SUNSET HILLS SUBDIVISION, FIRST ADDITION,
RESUBDIVISION OF LOT 3, BLOCK D

APPLICATION NUMBER 14 DATE September 15, 2011

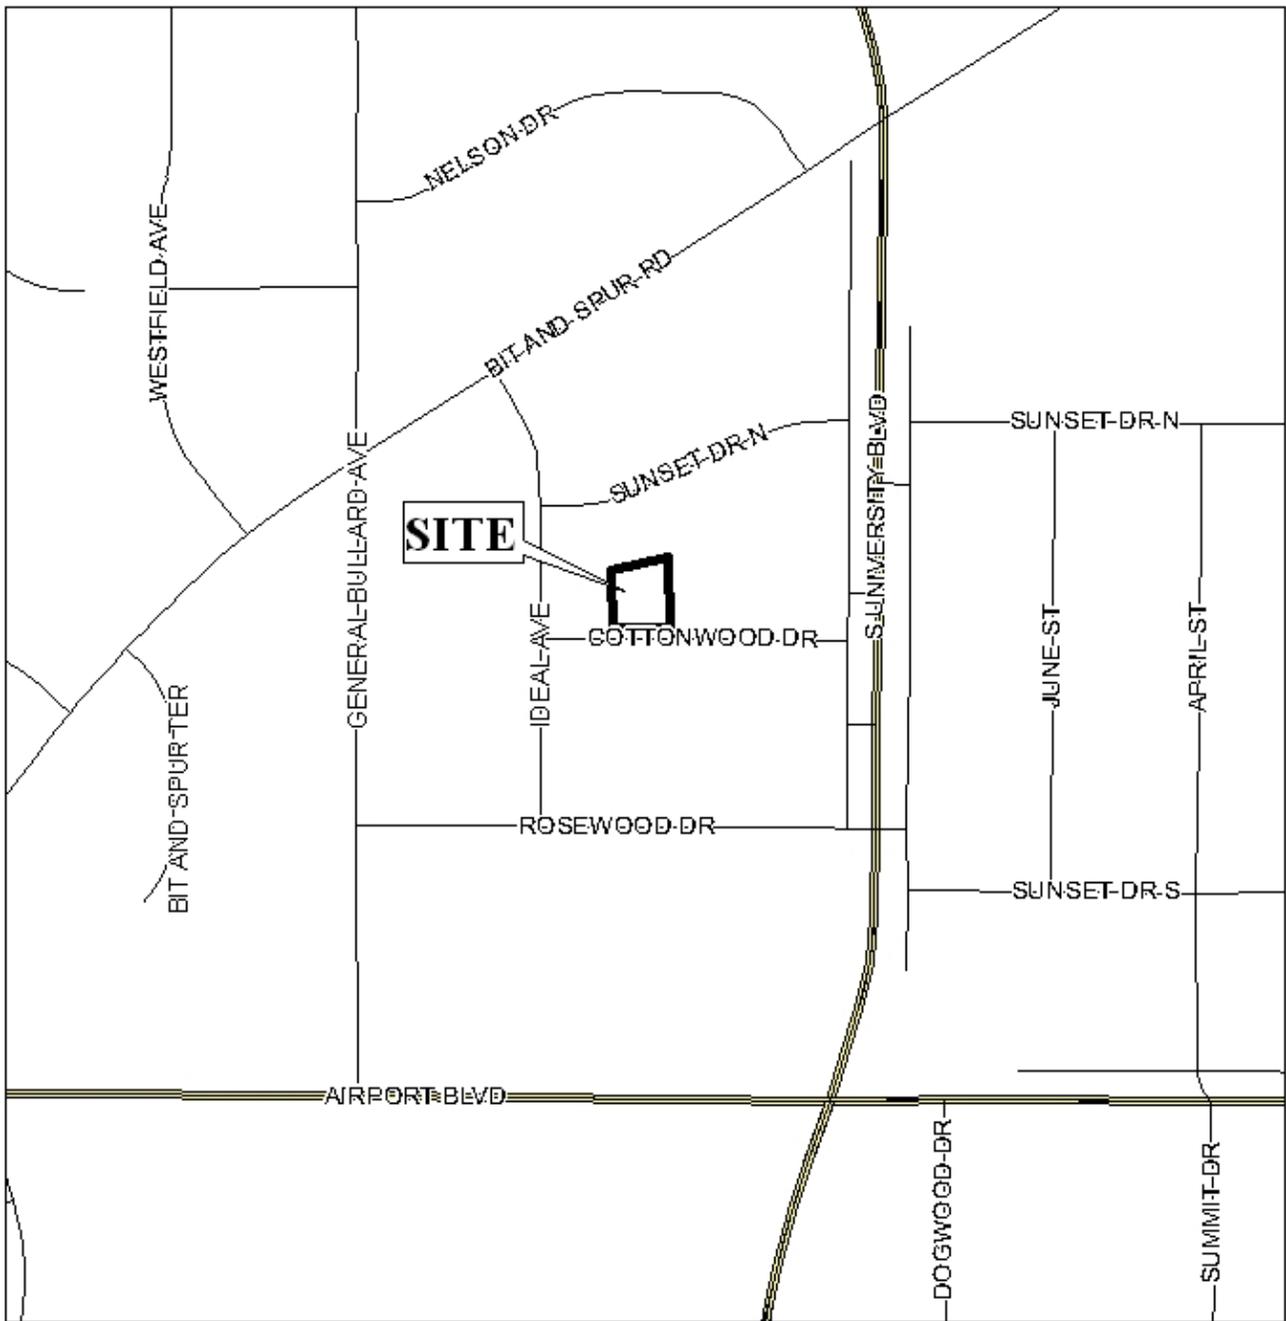
The proposed lots, as depicted, meet the minimum size and frontage requirements as regulated by the Subdivision Regulations. The 25-foot minimum building setback line and lot area sizes are depicted on the plat in square feet, and these should be retained on the Final Plat, if approved.

The lots front Cottonwood Drive to the South. Cottonwood Drive is a minor street provided with curb and gutter, and the plat depicts it with an adequate 50-foot right-of-way. No further dedication should be required. Should the application be approved, both lots should be limited to one curb cut, with the size, design, and exact location of all curb cuts to be approved by Traffic Engineering and conform to AASHTO standards.

- 1) retention of minimum building setback line and lot area sizes, in square feet, on the Final Plat;
- 2) placement of a note on the Final Plat stating both lots are limited to one curb cut each, with the size, design, and exact location of all curb cuts to be approved by Traffic Engineering and conform to AASHTO standards;
